August 7, 2013

RE: LORAIN COUNTY  
CITY OF AVON  
CONSTRUCTION STORM WATER  
PERMIT NO: 3GC06057\*AG  
STONEBRIDGE CREEK SUBDIVISION #12

**Figure 7 (left):** The ditch drains to a stream that runs parallel to the west of the site.

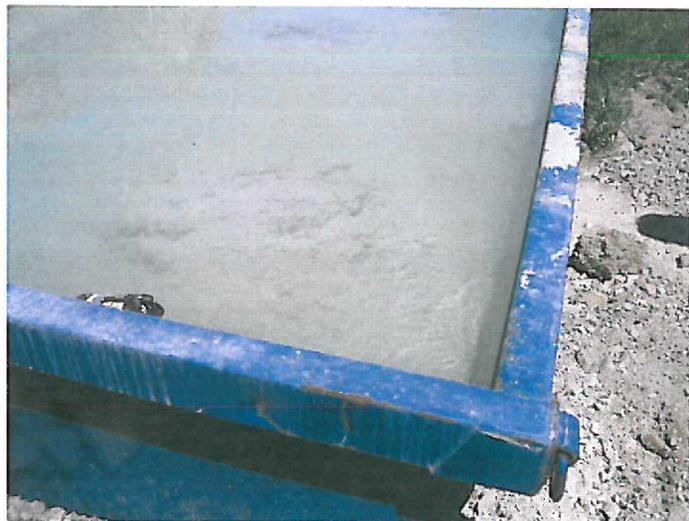
- A ditch to the west of the roadway leads into a stream that flows away from the site. **(Figure 7) Per the NPDES permit, structural practices shall be designed and implemented on site to protect all adjacent surface waters of the state from the impacts of sediment runoff.** Proper sediment and erosion controls are necessary to protect the stream from receiving sediment runoff from the site.
- **Non-sediment pollution controls require repair and maintenance as per the NPDES Permit.** (Figure 8) The concrete washout pit was full. Please remove hardened concrete and restore the washout pit to its original design capacity to prevent an unauthorized discharge of wastewater to the environment.
